ADDENDUM 01

BID FOR : *Campus Gateways, McNeese State University, Lake Charles, Louisiana 70607*

Addendum No. 01

PROJECT:
Campus Gateways
McNeese State University
Lake Charles, Louisiana
19-627-21-01, F.19002583
01-107-05B-13, F.01004545 (Supplement)

A-104R1

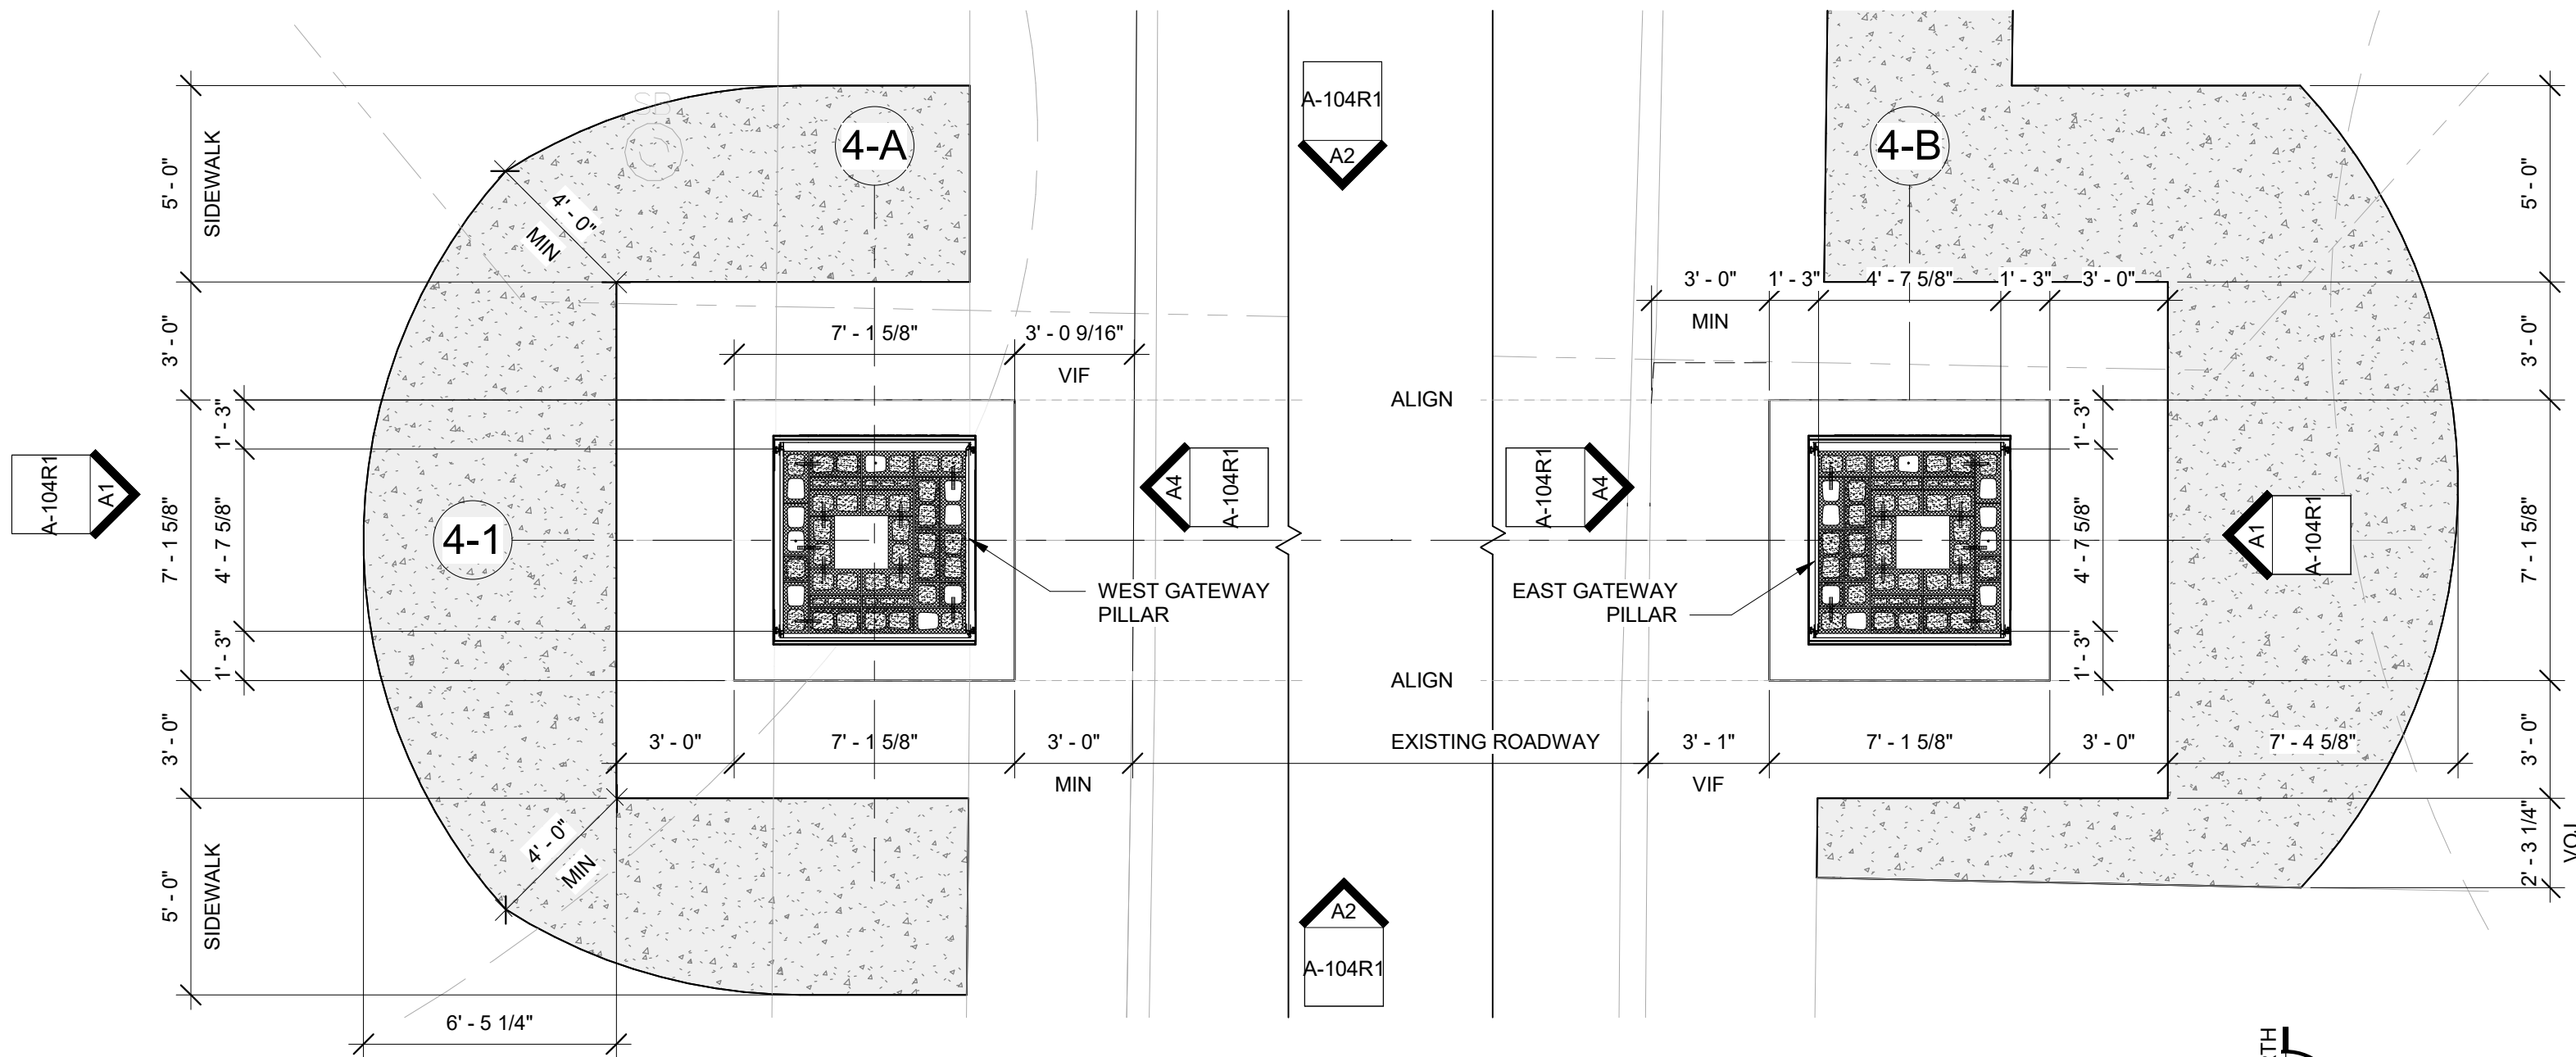
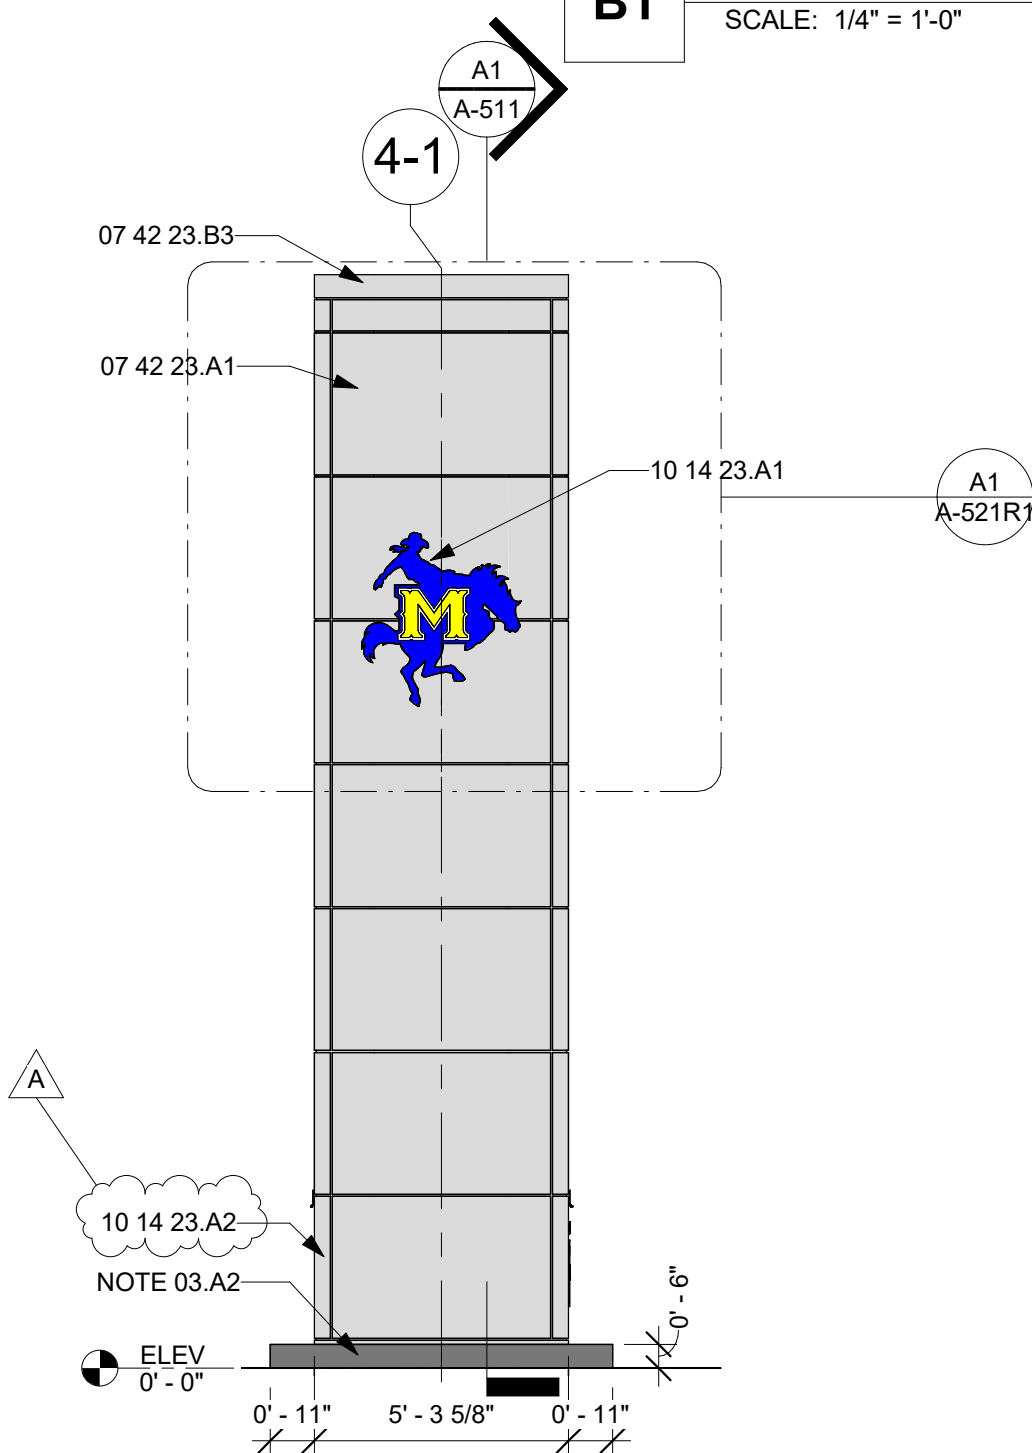
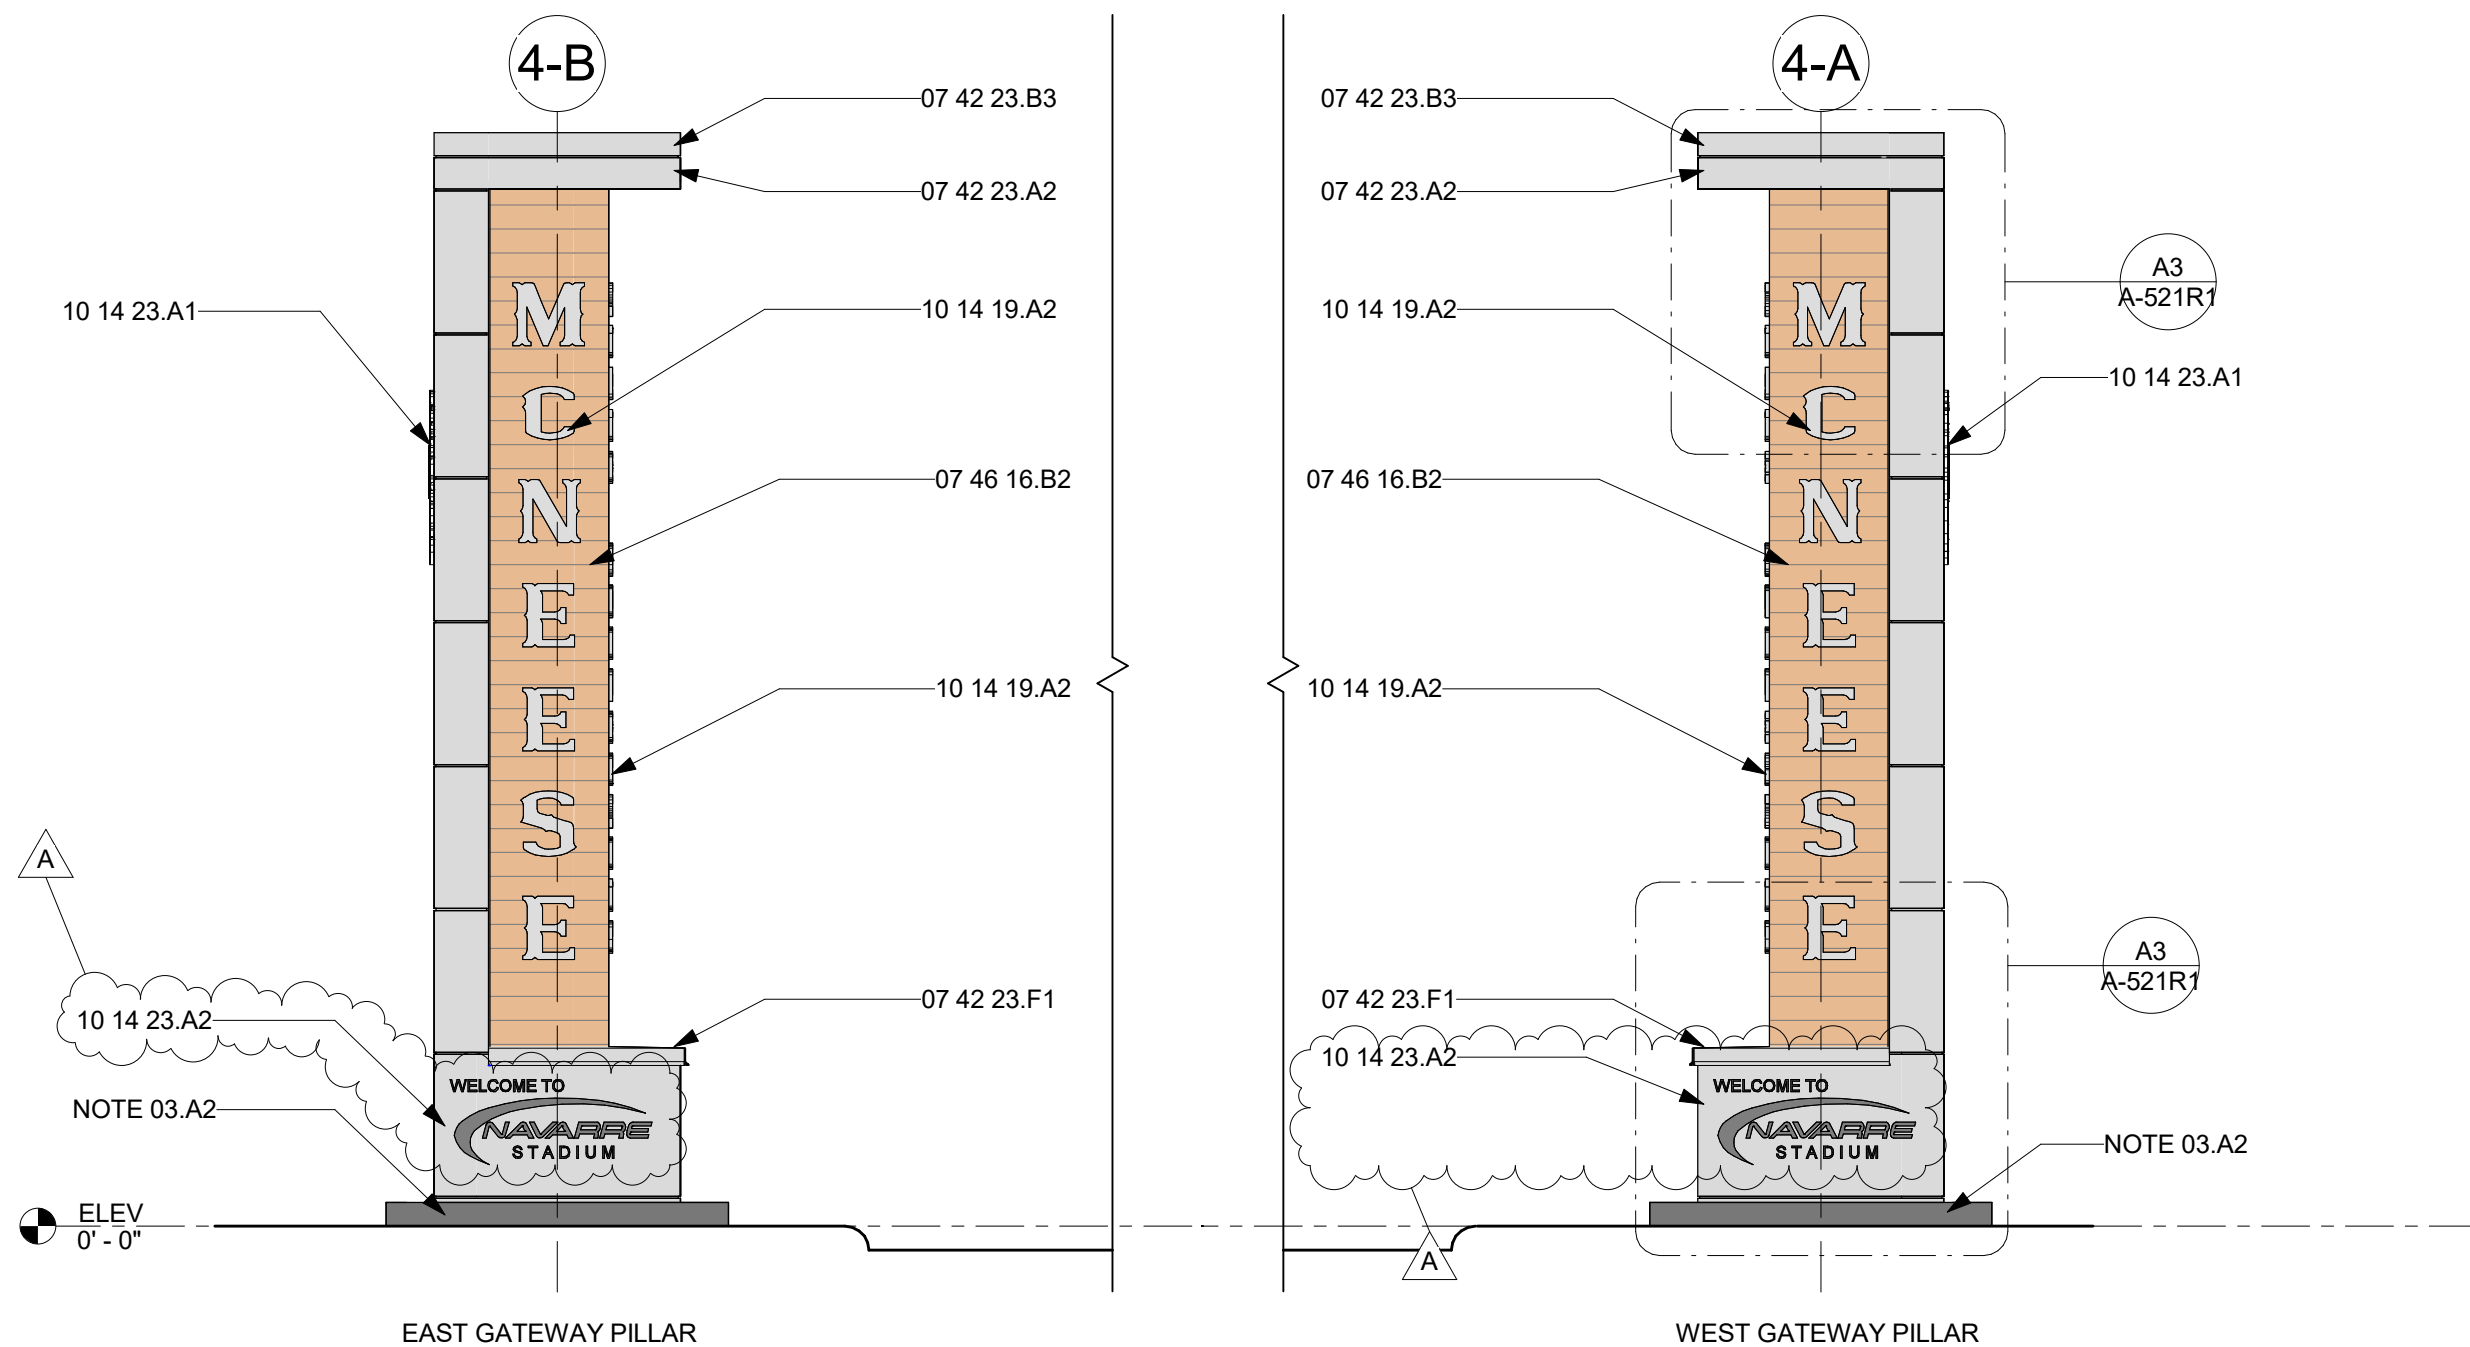
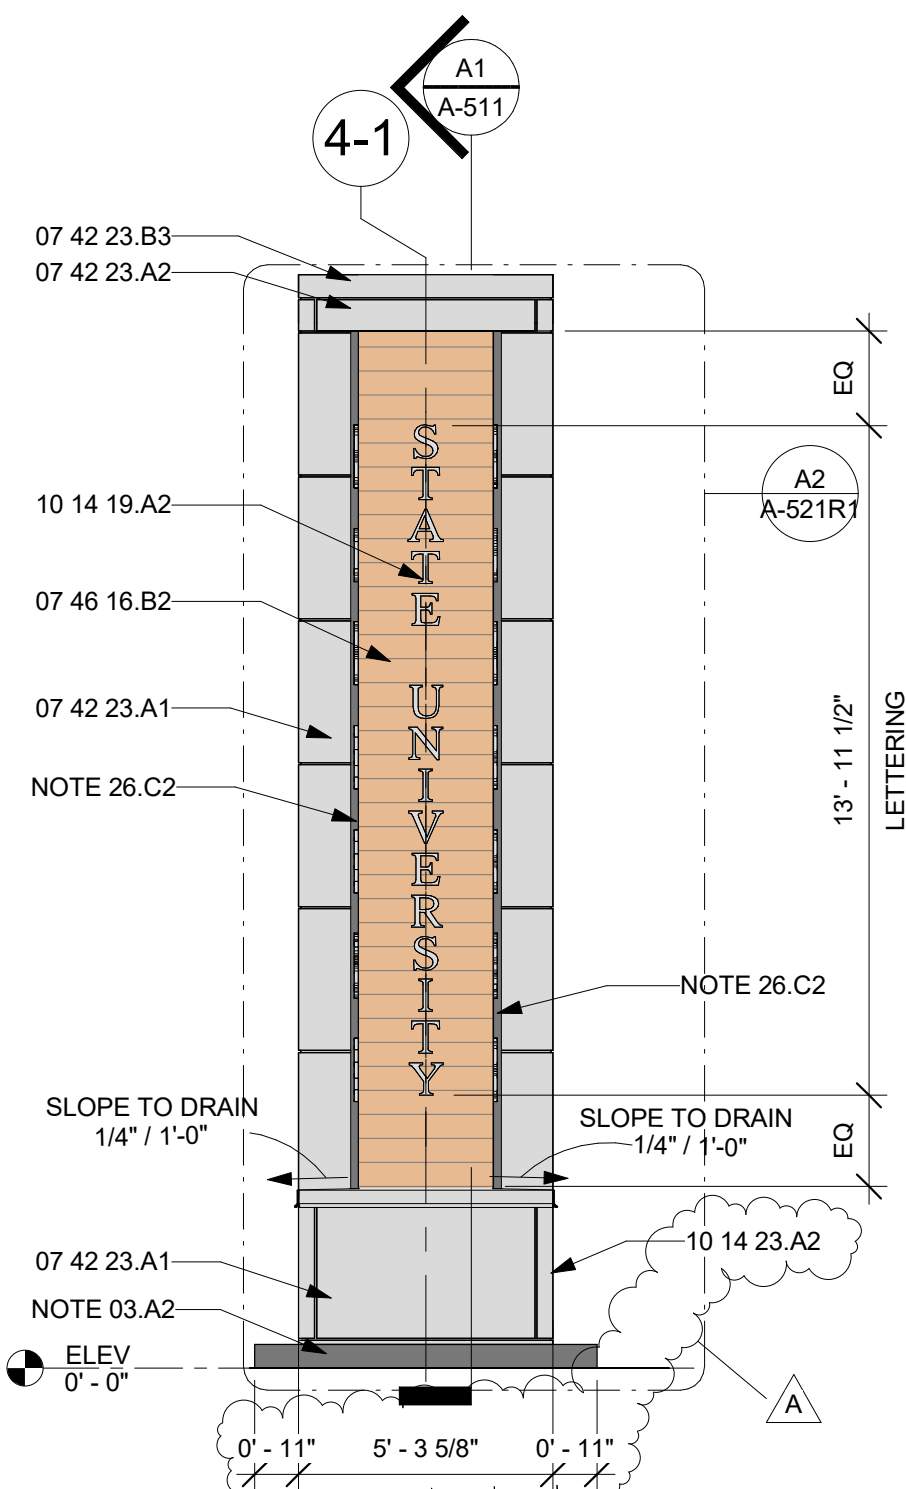
- a. Sheet A-104R1 Gateway 04- Plans and Elevations.
- b. Sheet A-105R1 Gateway 05- Plans and Elevations.
- c. Sheet A-521R1 Gateway Signage.
